# United States Patent and Trademark Office

APPLICATION NO.	FILING DATE	FIRST NAMED INVENTOR	ATTORNEY DOCKET NO.	CONFIRMATION NO
10/629,703	07/30/2003	Traugott Marquardt	1509-429	5353
7	590 11/02/2004		EXAM	INER
HEWLETT-PACKARD COMPANY			NGUYEN, CHI Q	
Intellectual Property Administration P.O. Box 272400			ART UNIT	PAPER NUMBER
Fort Collins, CO 80527-2400			3635	
•			DATE MAILED: 11/02/2004

Application No.	Applicant(s)		
	10/629,703	MARQUARDT, TRAUGOTT		
Office Action Summary	Examiner	Art Unit		
	Chi Q Nguyen	3635		
The MAILING DATE of this communication app Period for Reply	ears on the cover sheet with the d	correspondence address		
A SHORTENED STATUTORY PERIOD FOR REPLY THE MAILING DATE OF THIS COMMUNICATION.  - Extensions of time may be available under the provisions of 37 CFR 1.13 after SIX (6) MONTHS from the mailing date of this communication.  - If the period for reply specified above is less than thirty (30) days, a reply If NO period for reply is specified above, the maximum statutory period w Failure to reply within the set or extended period for reply will, by statute, Any reply received by the Office later than three months after the mailing earned patent term adjustm

FIG. 12.

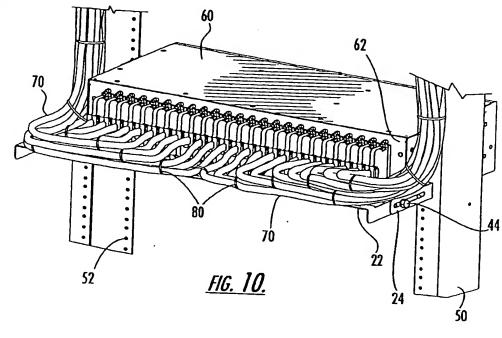
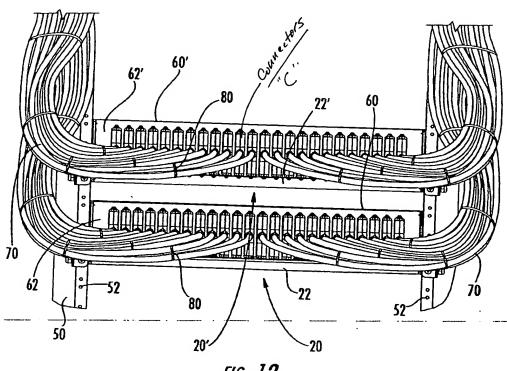
arranged opposite each other, and rows of connector C (see attached figure 12 with label) for routing cables pass through. It would have been obvious to one of ordinary skill in the art at the time the invention was made to modify the Feeney's computer subfloor support unit with Simonson, which having connectors on the frame structures, portal-like and sidebars. The motivation for doing so would have been to provide more integrity for the junction unit. Thus more cable connectors could be mounted along the sidebars for routing more cables.
